**SUBDIVISION, PLANNED UNIT DEVELOPMENT, &
SIDEWALK WAIVER STAFF REPORT****Date: October 19, 2006****DEVELOPMENT NAME**

Blevins Subdivision, First Addition to

LOCATION3941 Demetropolis Road
(East side of Demetropolis Road, 140± South of Halls Mill Road)**CITY COUNCIL
DISTRICT**

Two retail/warehouse buildings on a single building site.

SITE PLAN

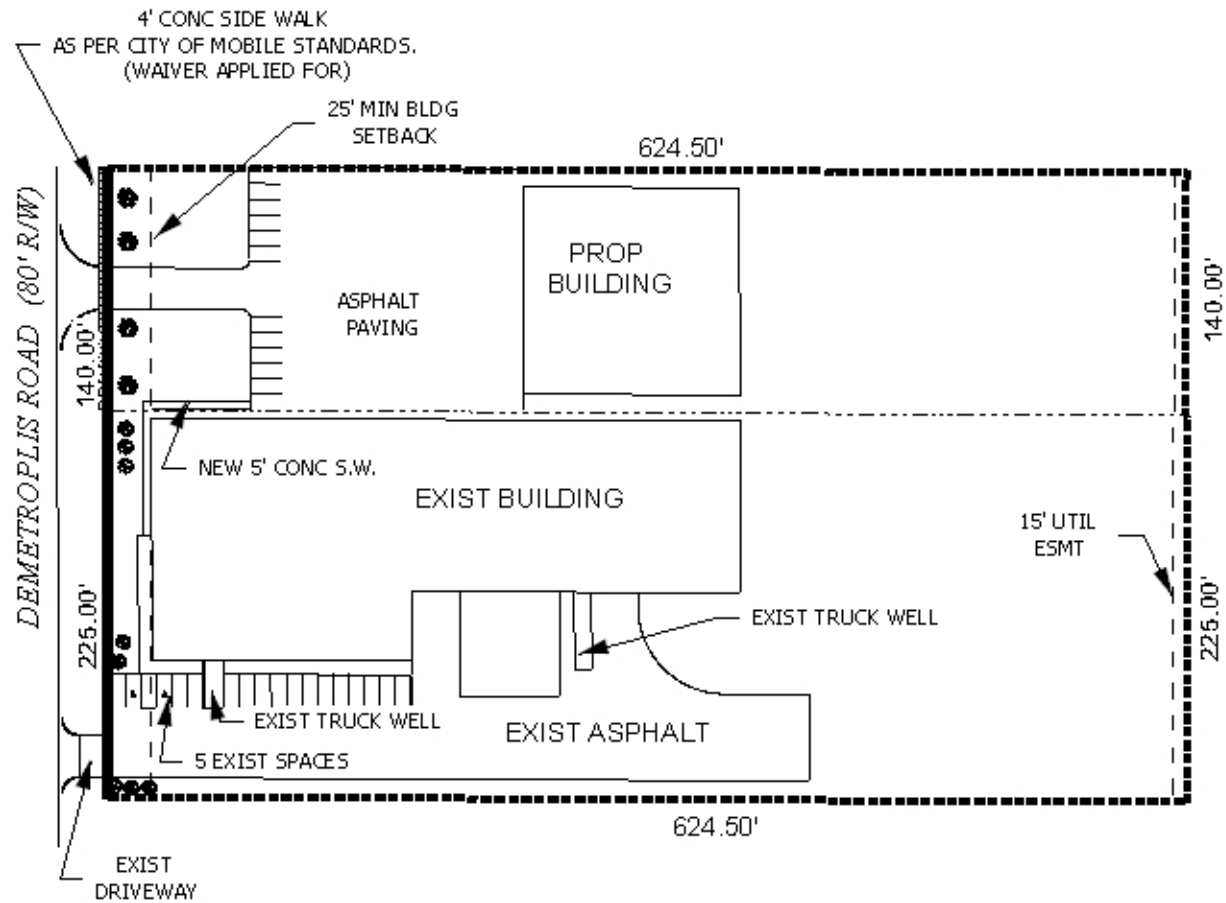
Since this site would provide 365-feet of frontage along Demetropolis Road, a note should be placed on the Final Plat stating that the development be limited to two curb-cuts, with the size, design and location to be approved by Traffic Engineering Department.

The site plan satisfies the requirements of the Zoning Ordinance regarding building site area, parking, tree & landscaping requirements and setbacks.

In addition, it has traditionally been the practice of the Planning Commission to require an extensive buffer between industrial districts and single-family districts. While the landscaping plan does not illustrate "vegetative buffering" along the East property line, these plantings would screen the existing industrial character of the site from the adjacent single-residential property. Due to these concerns, it is recommended that a 10-foot vegetative buffer be required along the East property line, in accordance with Section IV.D.1 of the Ordinance.

The applicant is also requesting a waiver of sidewalk construction requirements, citing the absence of sidewalks at neighboring properties and a steep slope at the site.

It should be noted that sidewalks do not exist along Demetropolis Road, and a sidewalk waiver has been approved at nearby properties along Demetropolis Road. Engineering comments that it is possible to construct sidewalk; however, there are no existing sidewalks present on adjoining properties.

Subdivision The plat meets the minimum requirements of the Subdivision Regulations and is recommended for Tentative Approval with the following condition: 1) a note be placed on the final plat limiting curb cuts to the approved Planned Unit Development.

Planned Unit Development The plat meets the minimum requirements of the Subdivision Regulations and is recommended for Tentative Approval with the following conditions: 1) a note be placed on the final plat limiting curb cuts to the approved Planned Unit Development; and 2) the provision of a 10-foot natural vegetative buffer along the East property line in accordance with Section IV.D.1 of the Zoning Ordinance.

Sidewalk Waiver Based on the preceding, it is recommended that this sidewalk waiver request be approved.
